SRR-ESH-2010-00101

SALTSTONE DISPOSAL FACILITY VAULT 2 CONSTRUCTION (U)

The purpose of this memorandum is to inform the South Carolina Department of Health and Environmental Control (SCDHEC) of a change in the Vault 2 disposal cell design described in General Condition B.1.b of Reference 1.

AREA Z SALTSTONE STORAGE TANKS AIKEN, SOUTH CAROLINA ANALYSIS AND DESIGN OF EXTERIOR CURB AT BASE OF WALL CROM JOB NUMBER 2008-M-084

Figure 1

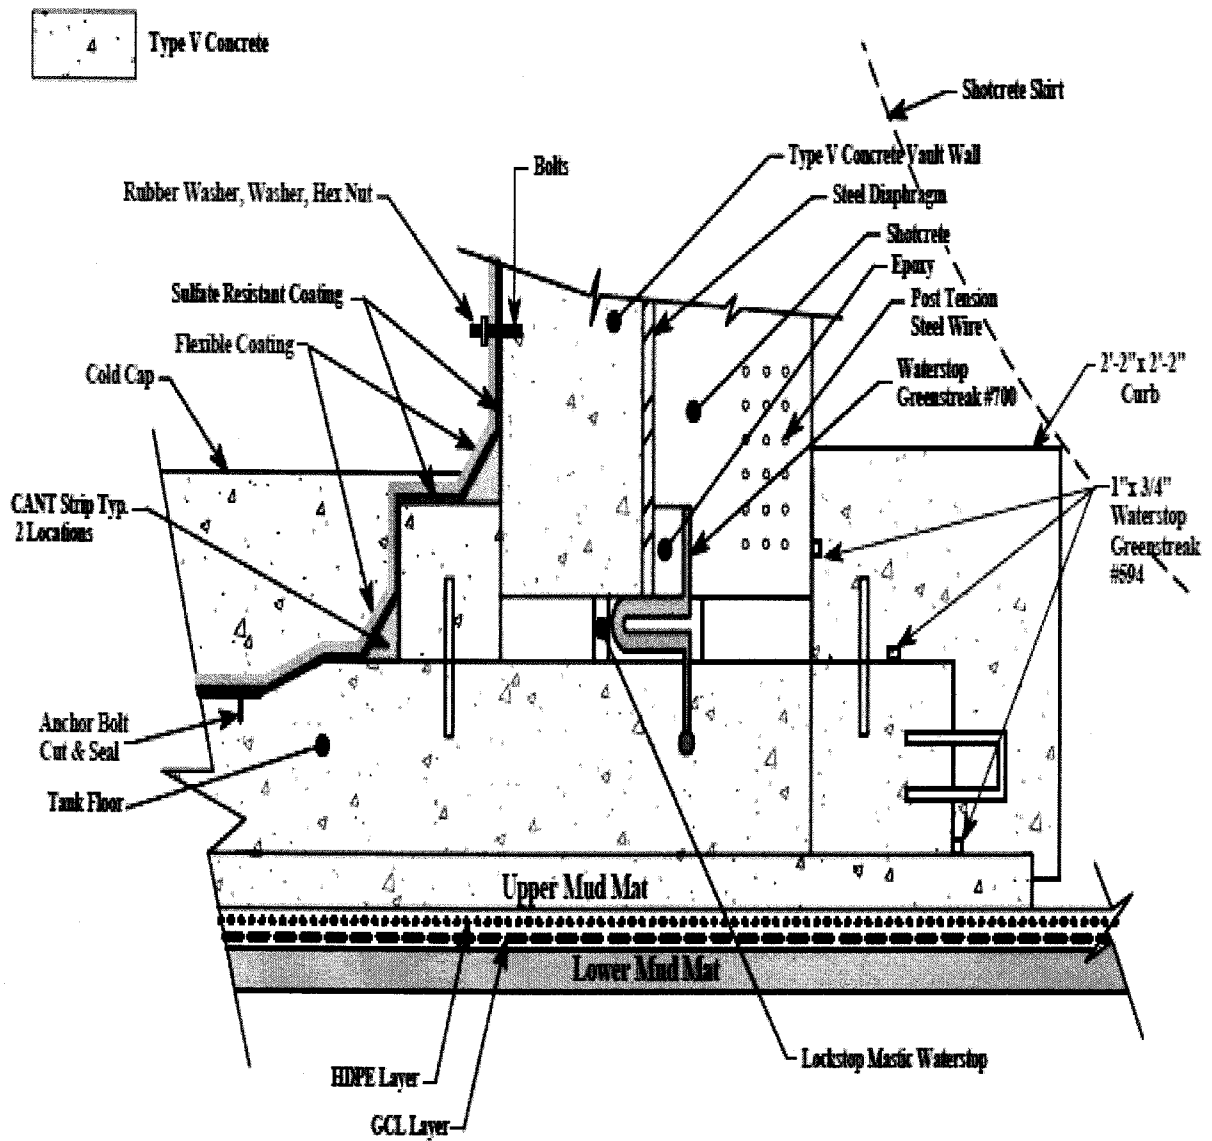
As was discussed during SCDHEC's visit on July 28, 2010, two external concrete curbs were proposed for installation on Vault 2, Cells 2A and 2B. The proposal has changed from the original concept to a one curb design, see Figure 1. The external concrete curb is a defense in depth measure being taken in an effort to aid the water tight design and as a design improvement for the Saltstone Performance Assessment (PA). The Saltstone PA assumes that over a long period of time (e.g., > 10,000 years) water from environmental sources will eventually infiltrate the disposal cell, will interact with the saltstone, and will migrate out of the cell through at least eight inches of sulfate resistant concrete at the wall and twelve inches of sulfate resistant concrete at the floor before it reaches the environment. The migration rate for the PA base case is assumed to be extremely slow.

The interior curb installed in Vault 2, Cells 2A and 2B, is designed to provide the eight inch wall concrete requirement at the wall to floor interface. However, the detection of moisture on the exterior of the cells at this interface during testing was evidence of a higher than expected migration rate. Similarly, moisture detected at the floor to upper mud mat interface was evidence of a higher than expected migration rate through the floor. Although the minor amount of moisture observed is well within the PA sensitivity analyses, an exterior curb as conceptually depicted in Figure 1 is being installed on Vault 2, Cells 2A and 2B, in order to ensure the Saltstone PA Base Case assumptions are not challenged. The exterior curb will be cast in place using sulfate resistant concrete and steel reinforcement. Hydrophilic material will be incorporated into the design of the exterior curb as an extra layer of defense to aid water tightness.

Note: Items shown in red are changes from original Vault 2, Cells 2A and 2B design.

FILE NO.
2008-M-084B
SHEET 1 OF 1

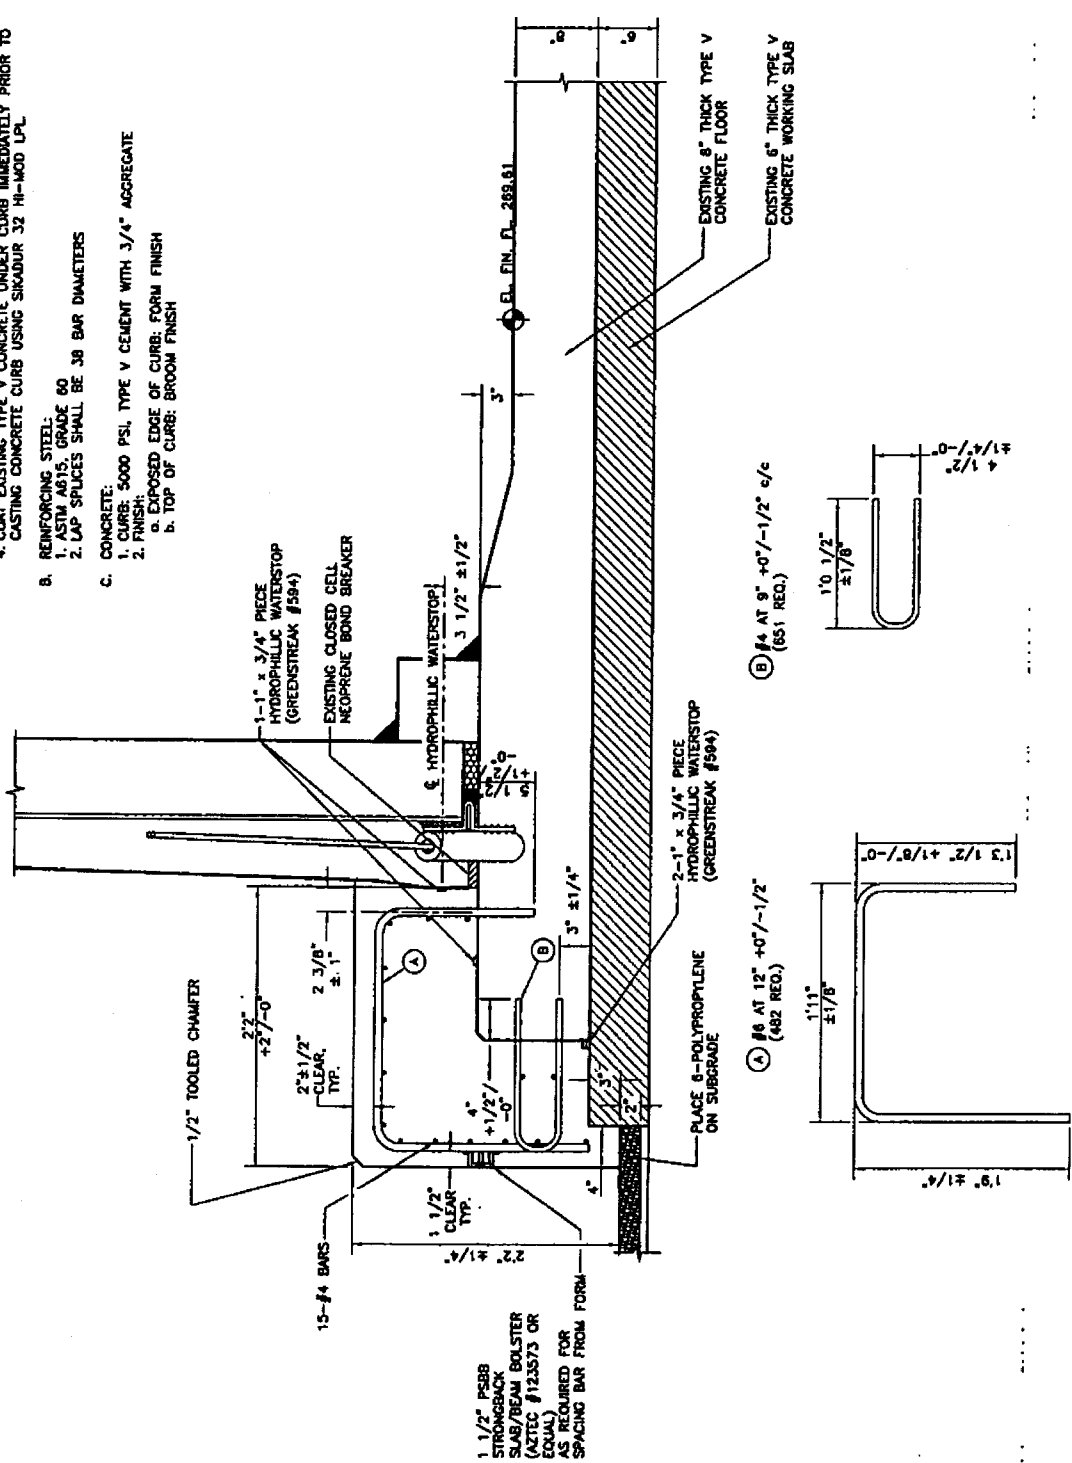
The concrete curb will be attached to the outside of the existing tank foundation using reinforcing steel dowels which are placed with an epoxy adhesive as depicted in the Exterior Curb Design drawing on page 1258 of the report. The attached product charts from Powers Fasteners shows the required embedment and ultimate tension and shear capacities for the epoxy adhesive. The embedment of the main #6 reinforcing bar in the curb which is anchored from the top of the footing is required to be 6 inches per the product data table; however, from a construction standpoint, this minimum embedment would encroach upon the bottom rebar mat in the footing. In order to alleviate this problem the rebar embedment will be reduced by 1/2 inch. As shown in the calculations titled Concrete Curb Design Analysis 1 and Concrete Curb Design Analysis 2, the curb rebar interaction is approximately 0.62 or 52% of the 1.2 allowed by Code. Based on stress levels calculated, the curb rebar will still have sufficient capacity, therefore 5 1/2" embedment depth for the curb anchors is acceptable.

Figure 1 Observed Leak Sites and Postulated Pathways

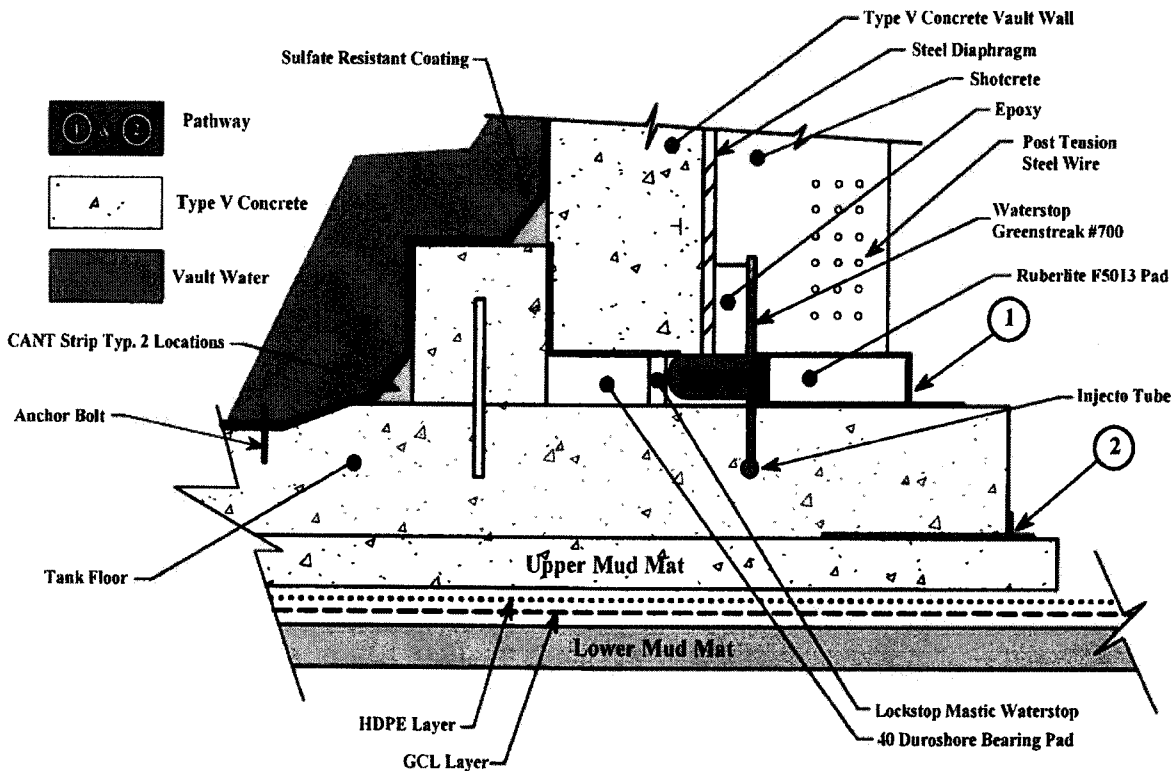
Inherent to the exterior wall design at the wall and floor interface are small cavities where different materials of construction meet (e.g., outer surface of waterstop, seismic cables, neoprene pad, and shotcrete, See Figure 1). These cavities can trap minor amounts of water (a.k.a., construction water) from concrete curing and rainwater. The tank designer neither previously identified nor communicated to SRR a potential of having water other than that originating from the interior of the tank during testing.

Subsequent re-tests of SDCs 2A and 2B with a dye tracer confirmed moisture exhibited by damp spots and presence of dye in several locations at the wall to floor joint and at the floor to mud mat interface (See Figure 1 points 1 and 2). Neither damp spots nor traces of dye were ever observed in the roof/wall interface nor the wall/wall interfaces. Interior SDC inspections revealed coating failures, primarily in the floor, that provided a pathway for the moisture to interact with the cell concrete. Although coating and floor repairs were made to the SDCs, upon re-test, SDC 2B again failed to meet the dye tracer test

Figure 2 SDU 2 Design Enhancements (red font)

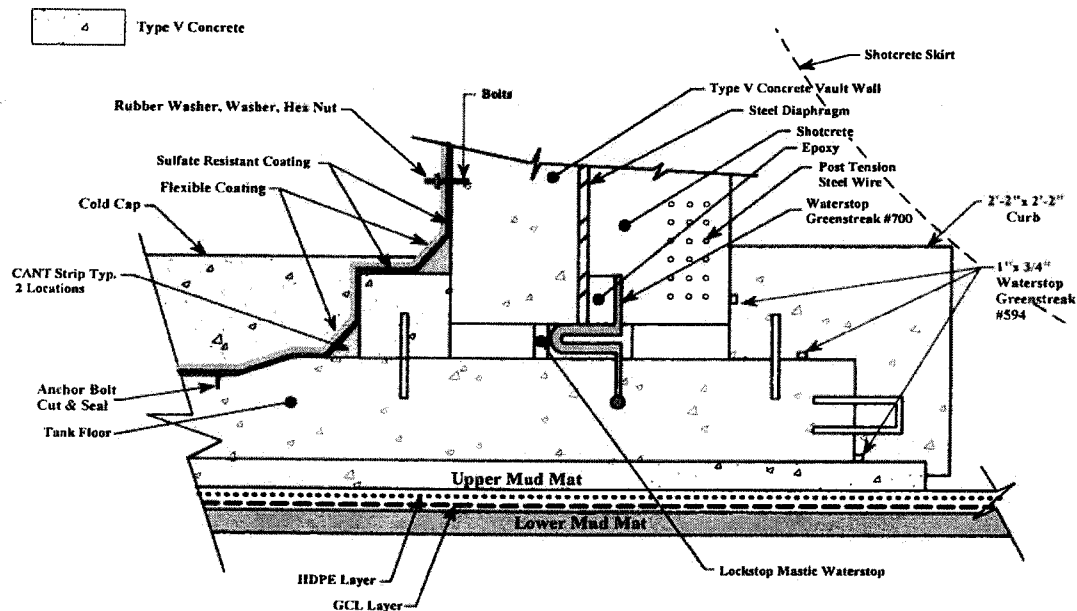
The following repairs and modifications are being pursued to resolve the SDU 2 water tightness issues in preparation for the next water tightness test (Figure 2):

- Cut the floor drainwater collection system anchor bolts flush with the floor and repair/overlay the areas using the original TL-45S Novolac epoxy to form a continuous cell floor lining. (Reference 4.5). To eliminate the potential for damage to the concrete floor during the repair, anchors will be cut and ground flush with the floor. No rotary hammers or impact equipment will be used to remove the anchors to guard against crack development.

- Install a washer, gasket and nut mechanical sealing system to each of the drainwater collection system anchor bolts that remain in the walls for sheet drain attachment (Reference 4.6). This mechanical system provides a positive and verifiable seal that addresses any potential sealing discontinuities at the interface between the threads of the anchor and the wall coating/lining system.

- Install an exterior curb system with 8 inch (minimum) Type V concrete that addresses the areas along the wall to floor interface and at the floor to upper mud mat interface. The objective of this curb is to restrain wall movement that might affect the interior coatings and to provide an additional moisture barrier of Type V concrete that supports the Performance Assessment base case assumptions. (Reference 4.7)

Figure 3 Tank Wall Displacement During Water Tightness Tests

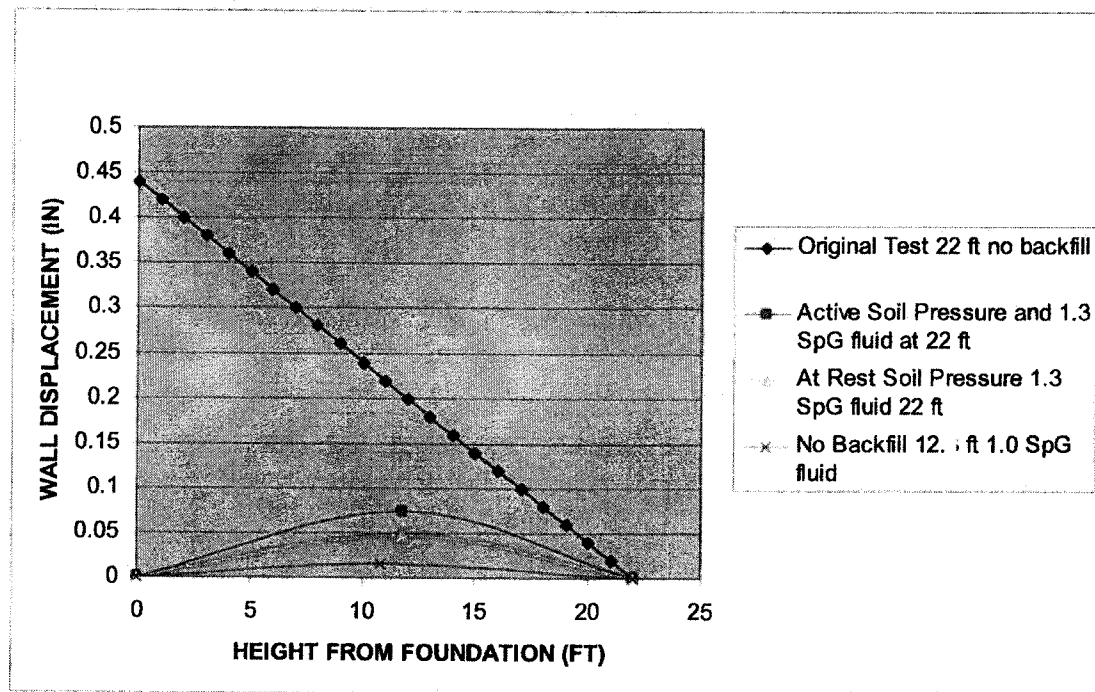
The additional 60 mil thick application of Blome International EC-66 high performance flexible epoxy coating placed over the entire interior surface of the tank further ensures water tightness, in concert with the original sulfate resistant coating. The manufacturer specifies a tensile elongation of 110% for the EC-66 (Reference 4.20) and 2% for the Novolac epoxy (Reference 4.21). The maximum wall deflection with active soil pressure and the cell filled to 22 feet with liquid of 1.3 SpG occurs approximately at mid height and is 0.073 inch. The maximum wall deflection of 0.073 inches results in a deflection at the curb-wall interface of 0.0075 inch which translates into a liner elongation of 0.75 %. This elongation is less than the rated elongation of the Novolac and EC-66 materials and will not challenge the integrity of the installed coatings (Reference 4.19). Resulting displacements calculated based on rigid body rotation mythology are conservative when compared to actual behavior of the tank. Actual wall behavior will result in shear and flexural rotation and not rigid body rotation.
